Date: 05/13/19  
To: STXDF Ride-On Trowel Owners  
From: Multiquip Product Department  
Subject: Spider Fastening Bolts — **Mandatory Update**

**Campaign:** Reference No. TR20190429

# Service Bulletin

## STXDF Spider Bolts and Washer Installation

Figure 1. Replacement Hardware and Loctite®

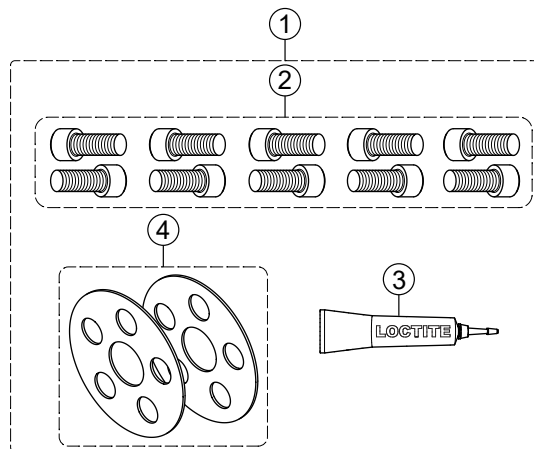
Replace existing left- and right-side spider assembly bolts with new zinc-plated bolts and hardened washers (one per side) to allow thread-locking fluid to properly set.

Item	Part No.	Description	Qty.	Remarks
1	43111-SK	Kit, STXDF Spider Hardened Washer	1	Includes items 2-4
2	939654	Screw, SHC M12-1.75 x 30 mm 12.9	10	
3	1477	Loctite #242 Blue 0.5 cc Bottle	1	
4	43784	Washer, STXDF, Spider	2

**Figure 6. Remove Left-Side Spider Bolts**

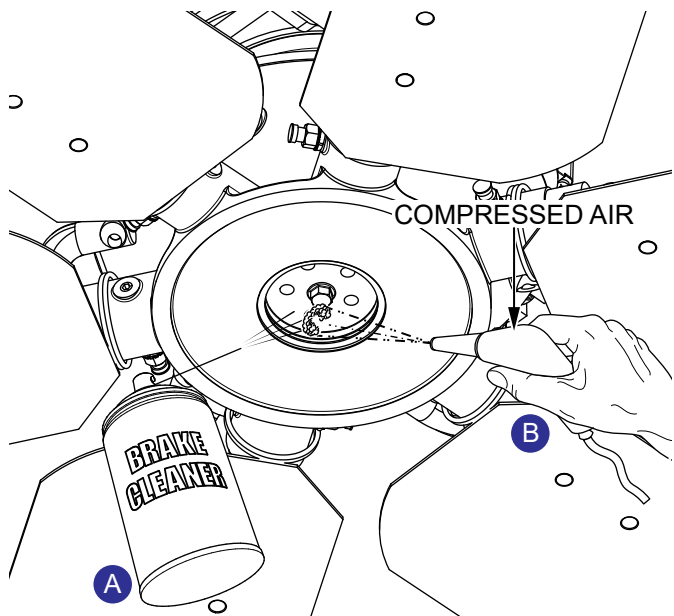
2. Remove and discard the five existing M12-1.75 x 30 mm SHC bolts (Figure 6) securing the left-side spider assembly to the bottom of the left-side hydraulic motor.

**DO NOT** remove the center retaining bolt (hex flange type) from the spider assembly. Only the 5 surrounding screws (with socket head caps) are to be replaced.

**Figure 8. Apply Loctite® 242™ to New Bolts**

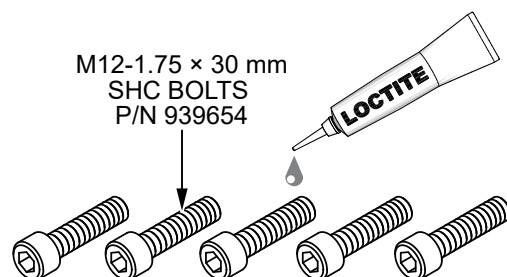
5. Apply Loctite® Blue 242™ (P/N 1477) to the threads on five new M12-1.75 x 30 mm SHC bolts (P/N 939654). See Figure 8.

**Figure 9. Install New Bolts and Washer**

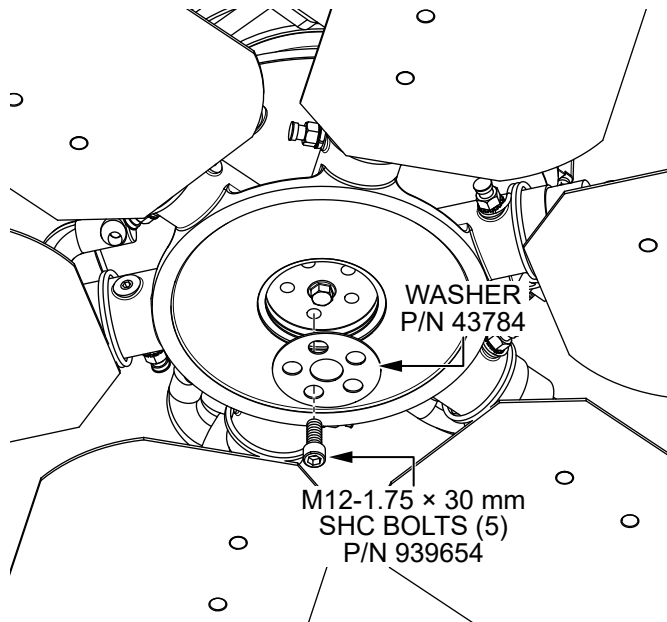
6. Install the five new M12-1.75 × 30 mm SHC bolts (P/N 939654) with one washer (P/N 43784) as shown in Figure 9. Torque the bolts in a star pattern to 40 lbf·ft.

7. Re-torque all five M12-1.75 × 30 mm SHC bolts (P/N 939654) to 90 lbf·ft in a star pattern.
8. Reinstall the left-side spider hub cap plug.
9. Repeat steps 1–8 on the right-side spider assembly.
